**Champlain Hudson Power Express ("CHPE")
Environmental Management & Construction Plan
Notice of Major Change**

Project: Champlain Hudson Power Express

Segment: 10

Notice Number: 084

Appendix E. Segment 10 Alignment Excursions

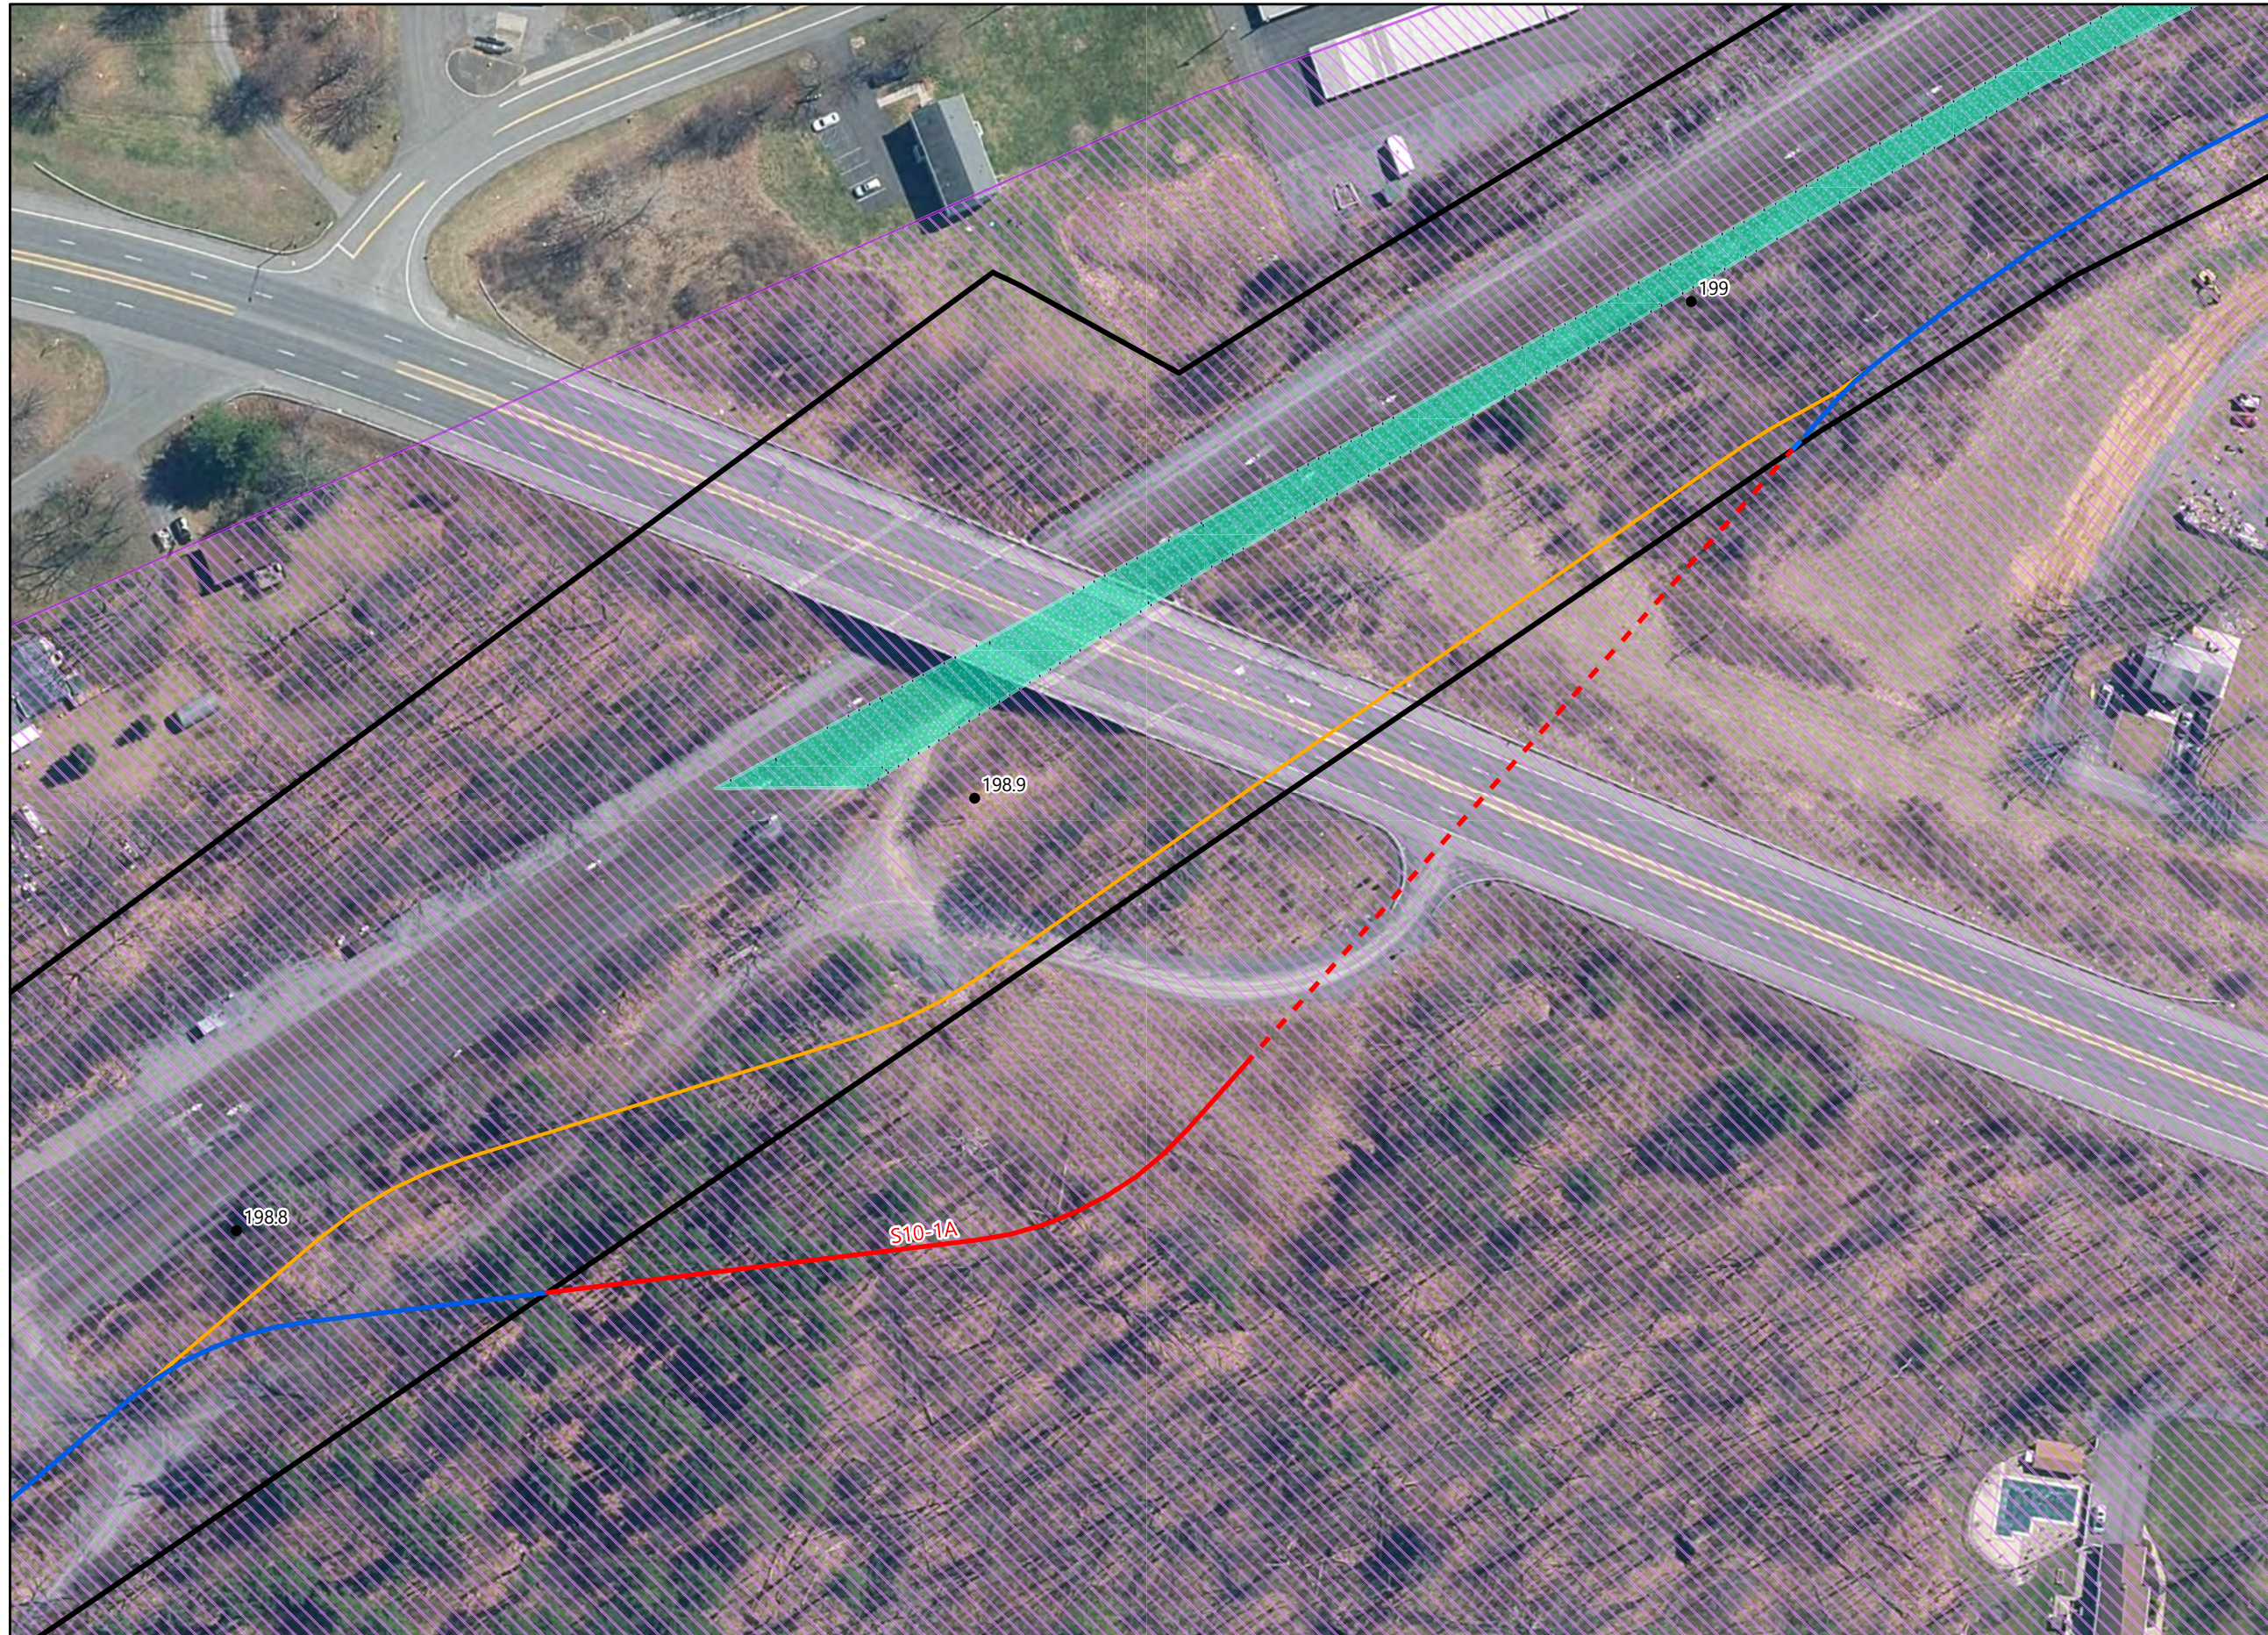
Excursion S10-A is located within the Town of Bethlehem beginning about 670' NW of US Route 9W Crossing of CSX tracks (approximately STA 60004 to 60017 on Sheet C-101 and C-102 of the Plan and Profile Drawings [Appendix C of the EM&CP]).

NYSDOT provided plans for a future bridge at the US Route 9W Crossing over CSX Railroad tracks and required that the CHPE alignment maintain a minimum clearance of 100 feet to the nearest proposed structure (wingwall). Given the constraints at or near the CSX tracks in conjunction with the NYSDOT clearance requirements, this ADZ Excursion request is grounded in engineering reasons and is the minimum necessary to feasibly achieve installation.

The anticipated ADZ exceedance constitutes a major change as it's 141 feet perpendicular to the ACZ at its furthest point; environmental impacts will be minimized, and the overall character of the Facility will not be changed. A detailed impact review and summary of environmental considerations are provided below. 525' HDD and 402' trench
